Access Compliance Report Public Rights-of-Way (Curb Ramps)

Main Street: NEWLAND_ST Cross Street: ROOSEVELT_AVE Location: SW

ADA ID: RPRK211001133959 Ramp Type: Type 1 - Perpendicular Diagonal Initial Pass/Fail: Fail Overall Compliance: No Severity Score: 20

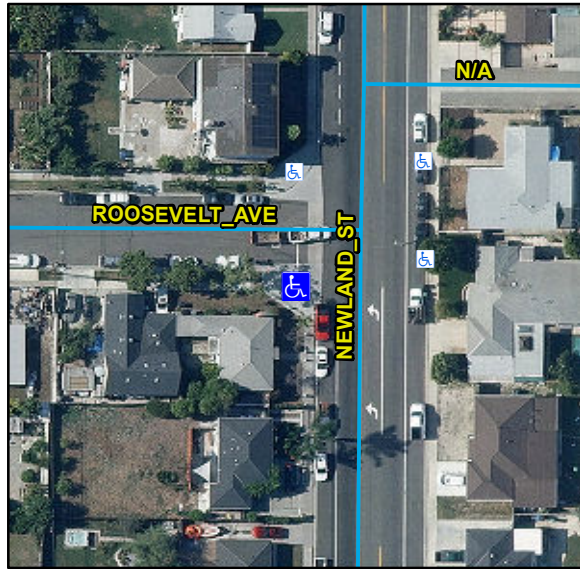
R304.2.2, R304.5.1, R304.5.3, STD 1115

Compliance	Description	Data	Compliance	Description	Data
N/A	Ramp Length (in)	170	N/A	Flare Type LT	
No	Ramp Width (in)	36			N/A
No	Ramp Run Slope (%)	11.3	N/A	Flare Slope LT (%)	N/A
No	Ramp Cross Slope (%)	4.4	N/A	Flare Traversable LT	N/A
N/A	Landing Present	N/A	N/A	Flare Type RT	
N/A	Landing Length (in)	N/A			N/A
N/A	Landing Width (in)	N/A	N/A	Flare Slope RT (%)	N/A
N/A	Landing Run Slope (%)	N/A	N/A	Flare Traversable RT	N/A
N/A	Landing Cross Slope (%)	N/A	N/A	DWS Provided	N/A
N/A	Landing Movement Obstructed?	N/A	N/A	DWS Contrast	N/A
	Landing Movement Type	N/A	N/A	DWS Length (in)	N/A
N/A	Landing Shared	N/A	N/A	DWS Full Width	N/A
N/A	Clear Space	Yes	N/A	DWS Offset Left (in)	N/A
N/A	Clear Space To Crosswalk (in)	N/A	N/A	DWS Offset Right (in)	N/A
N/A	Marked Crosswalk 1	No	N/A	Marked Crosswalk 2	No
	Crossing 1 Direction	E		Crossing 2 Direction	N
	Marked Crosswalk 1 Width (in)	N/A		Marked Crosswalk 2 Width (in)	N/A

Remove & Replace Curb Ramp With Two New Directional Ramps or Equivalent.
